**NOTICE OF
SPECIAL MEETING OF THE PLANNING AND ZONING COMMISSION
HICKORY CREEK TOWN HALL
1075 RONALD REAGAN AVENUE, HICKORY CREEK, TEXAS 75065
MONDAY, OCTOBER 05, 2026, 6:00 PM**

**Re: HTeaO Store #395 – 3080 FM 2181 (Lot 4, Block A – Lennon II Addition)
Site Plan and Landscape Plan
5th Review (3rd Review of revised submission)**

**Re: HTeaO Store #395 – 3080 FM 2181 (Lot 4, Block A – Lennon II Addition)
Final Plat
4th Review**

RE: HteaO Store 395 - Drainage Study in support of Final Plat (Lots 2A and 2B) and Site/Civil Plans for Lot 4 – 5th Review

C1.1A

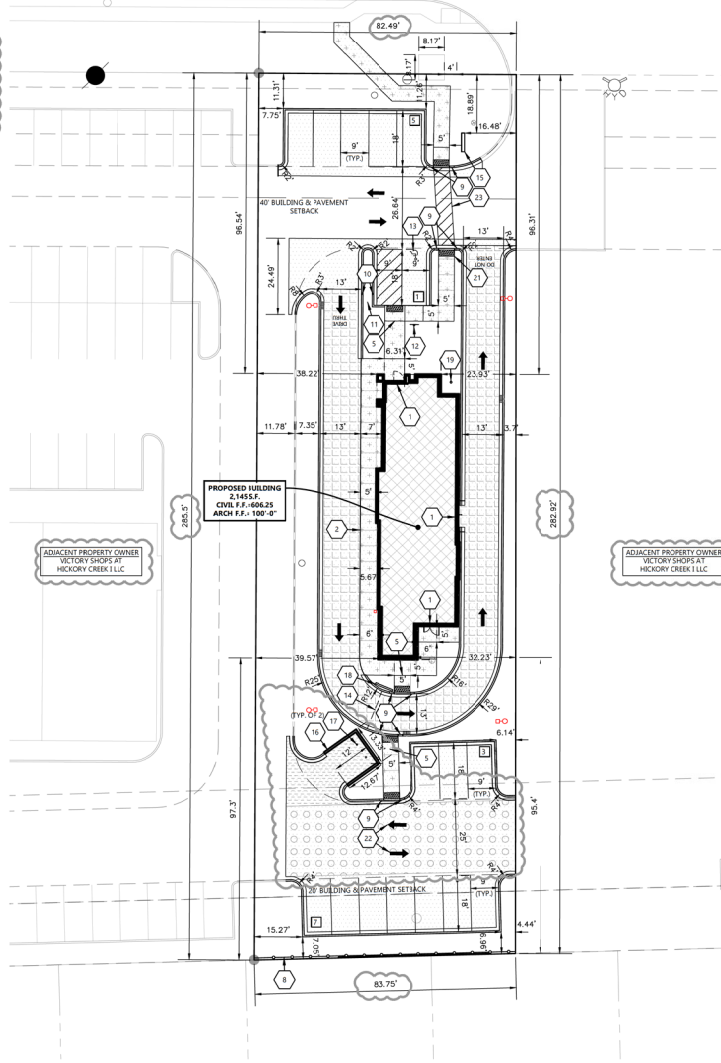
1. Please include lot dimensions on plan.
Comment addressed.
2. Please include the adjacent lot owner information.
Comment addressed.
3. Please include the FEMA Floodplain standard note, typically shown on platting.
Comment addressed.
4. Please include the "For Town Use" box
Comment addressed.

LS1.00

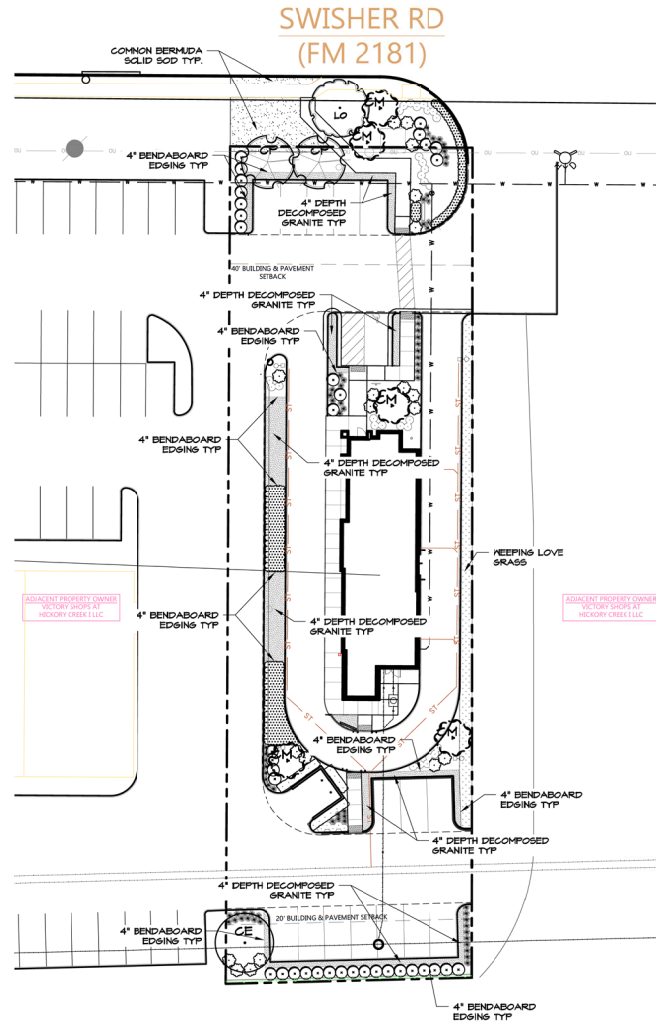
1. Please update title box of project information. It does not match Site plans.
Comment addressed.
2. Please add survey information, town and county and preparation date.
Comment addressed.
3. Please include the "For Town Use" box.
Comment addressed.

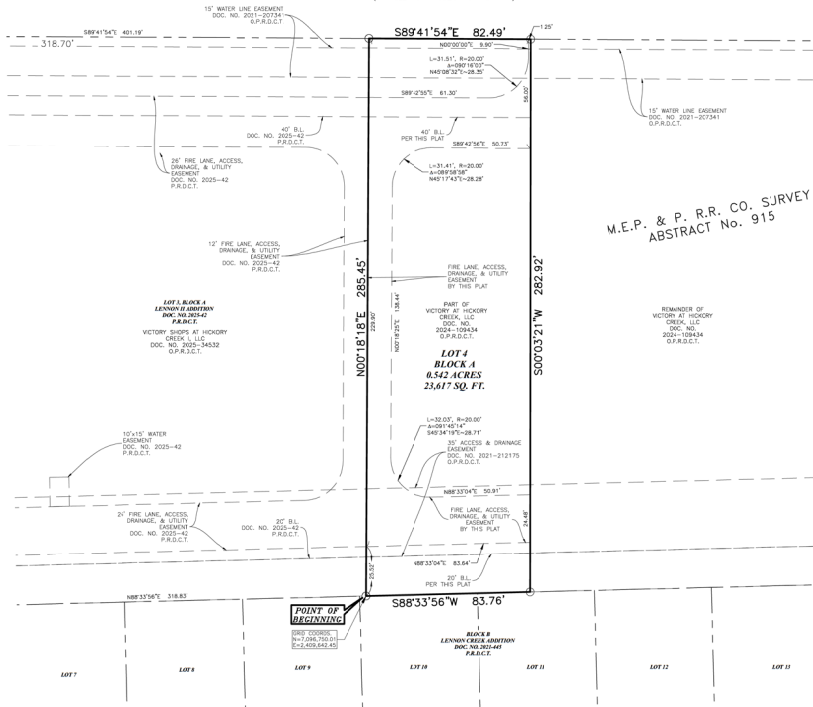
1. Show Town Limits on Final Plat.

Comment not addressed. Town Limits are located in the middle of the ROW across from the property and do not directly impact the property. Halff is ok approving the Final Plat without this shown.
